# SERVICE INFORMATION

Vol. 1 No. 8

# LAND-ROVER PETROL AND DIESEL MODELS

October, 1972

Fig. 1 Fuel pump installation

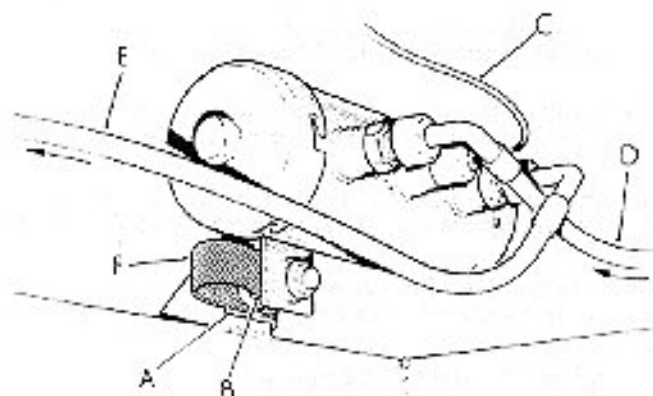
MODIFICATION: Introduction of Bendix electric fuel pump, replacing the S U fuel pump previously used, to overcome problems of corrosion.

The Bendix fuel pump is being fitted to current Land-Rover 109 vehicles with 2.6 litre engine.

**Fig. 2** Removal tool for pinion head bearing

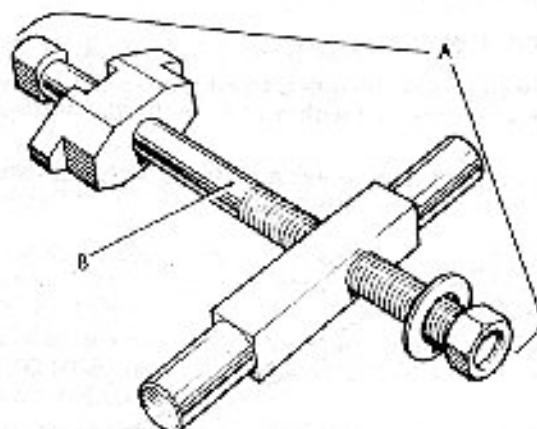
**MODIFICATION:** Introduction of a lengthened centre bolt for the differential pinion head bearing removal tool; the associated press block has also been modified to give improved contact with the head bearing. The centre bolt length has been increased from 180 mm (7 in.) to 230 mm (9 in.); press block diameter increased from 69 mm (2.7 in.) to 77 mm (3.0 in.).

On all Series III models and at the vehicle suffix letter change from 'G' to 'H' on Series IIA models, the pinion oil seal retainer is integral with the differential casing and not removable as previously; therefore a longer centre bolt has been provided for the Service tool used to remove and refit the pinion head bearing cup, to cater for the extra depth of casing involved.

Lengthening the centre bolt has resulted in a tool number change from 262757 (which remains suitable for early models) to 262757A which is suitable for both early and late models. The longer centre bolt is available separately under Part No. 262757A detail 3 to enable holders to modify their original tool Part No. 262757 which is then suitable for both early and late models.

Fig. 3 Press block for pinion head bearing

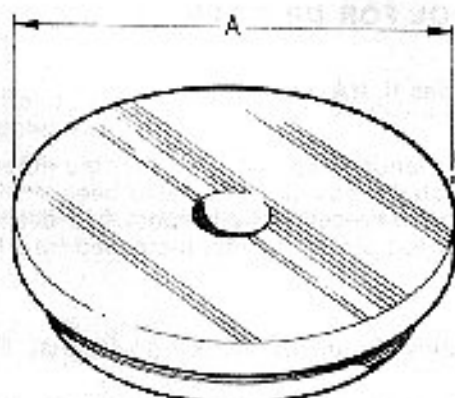
In conjunction with the above modification, the opportunity has been taken to provide a new press block which gives a greater contact area with the pinion bearing cup. The new press block Part No. 262757-1 replaces the earlier press block Part No. 262758 for the following models:

A—Early tool Part No. 262758 measures 69 mm (2.7 in.).  
Later tool Part No. 262757-1 measures 77 mm (3.0 in.)

Fig. 4 Spanner for stub shaft nut

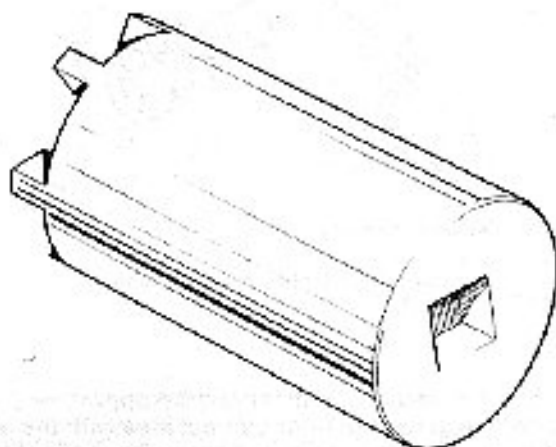
MODIFICATION: Introduction of a Service tool for removing/refitting the circular castle nut which retains the front hub driving member and the axle stub shaft.

REMARKS: The above Service tool is designed to engage in the castellations of the circular castle nut. The free end is provided with a 12.7 mm (0.500 in.) square hole to accept a suitable wrench.
